REPORT TO THE MILWAUKEE HISTORIC PRESERVATION COMMISSION:

2831-33 N. Sherman Boulevard (Sherman Boulevard H.D.)

STAFF REPORT:

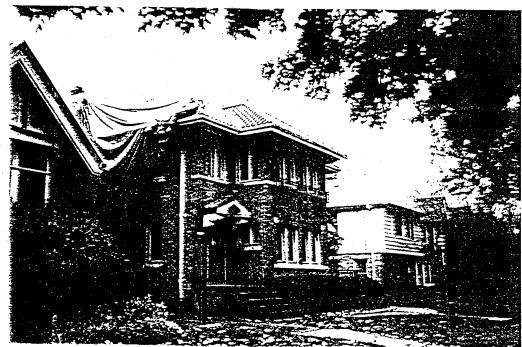
The applicant is requesting a Certificate of Appropriateness (COA) to allow for replacement of the pressed metal Spanish tile roofing material on the house and garage located at 2831-33 N. Sherman Boulevard. The house was built in 1924, is constructed of brick and has Mediterranean Revival influence. This house roof design is similar to at least 14 other buildings in the district. The metal roofing tiles at 2831 N Sherman boulevard appear to be original and have been in poor shape for many years according to the applicant who has owned the property since 1983. The main house roof tear-off had already begun before the contractor could be notified of the COA requirement. Unfortunately, the roof on the garage was replaced with 3-tab shingles before the owner could be contacted.

Staff has been on the World Wide Web for several days hunting down comparable materials. The contractor has also found a metal tile design that comes in sheets up to 3' x 20' long that would work for this project. If the owner consents to the installation of the metal tile design the project may start immediately. However, the asphalt/fiberglass architectural shingle is not appropriate for this house, and should not be installed. The shingles on the garage should also be shingled over to maintain the consistency of the site. The roofing replacement as amended by staff is not in keeping with the preservation guidelines for the district.

Staff recommends approval of a Certificate of Appropriateness (as amended) for re-roofing proposed at 2831-33 N. Sherman Boulevard subject to the following conditions:

- 1. The roof must be replaced with like-with-like pressed metal tiles of a Spanish tile design or a comparable metal panel design approved by staff. No 3-tab asphalt or fiberglass shingles must be installed.
- 2. The garage roof must be refinished to resemble the main house. Upon completion both the house and garage should have a similar roof design and appearance.
